HORSHAM DISTRICT COUNCIL CONSULTATION

TO:	Horsham District Council – Planning Dept
LOCATION:	Broomers Hill Park Broomers Hill Lane Codmore Hill West Sussex
DESCRIPTION:	Variation of conditions 19, 20, 22, 23, 24, 30, 31, 36, 38, 39, 40, 42 and 43 of previously approved application reference DC/13/1048 (Proposed development of 10 No. B1/B8 units with 55 parking spaces, 2 disabled spaces & 10 LGV parking spaces and outline consent for a further B1/B8 unit with 10 car parking spaces) to combine the two approved buildings into one single building.
REFERENCE:	DC/26/0975
RE-CONSULTATION:	1 st set of comments in black 2 nd set of comments in blue 3 rd set of comments in green
RECOMMENDATION:	Modification Modification

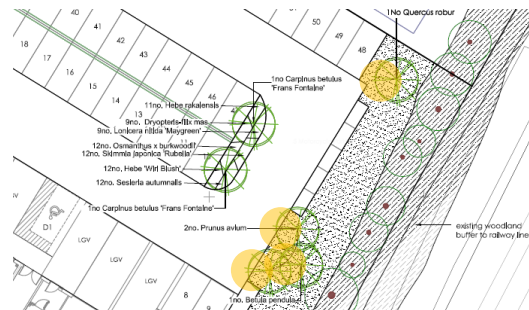
1. We recommend that chemical fertilisers, pesticides and herbicides including glyphosate are not to be applied at any time due to impacts on existing and proposed ecological features. This is also in line with objectives found within the Sustainability Statement. Alternative methods for weeding should be considered, except for Schedule 9 species; please refer to pan-uk.org for guidance and [resources](#). Please amend the "TREATING TOPSOIL" and "GENERAL TOPSOIL STORAGE" sections accordingly.

[Amended, with thanks. Closed.](#)

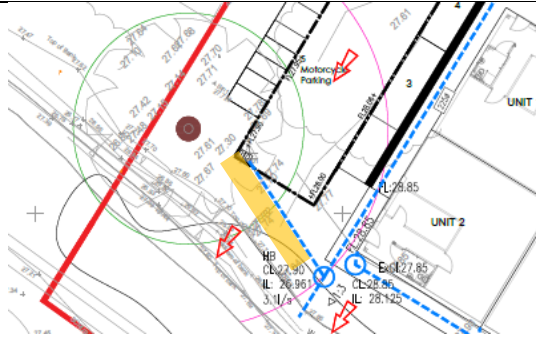
14. Please adjust this drainage run (highlighted in yellow) to avoid the RPA of English oak T4, if possible, to safeguard its retention.

15. Please note in addition that this encroachment within the RPA and beyond the Tree Protection Fencing is not reflected within the Arboricultural Impact Report or Tree Protection Plan. Therefore, if it cannot be altered, the advice of HDC's Arboriculturalist should be sought.

Drainage run adjusted, with thanks. Closed.

As above, closed.
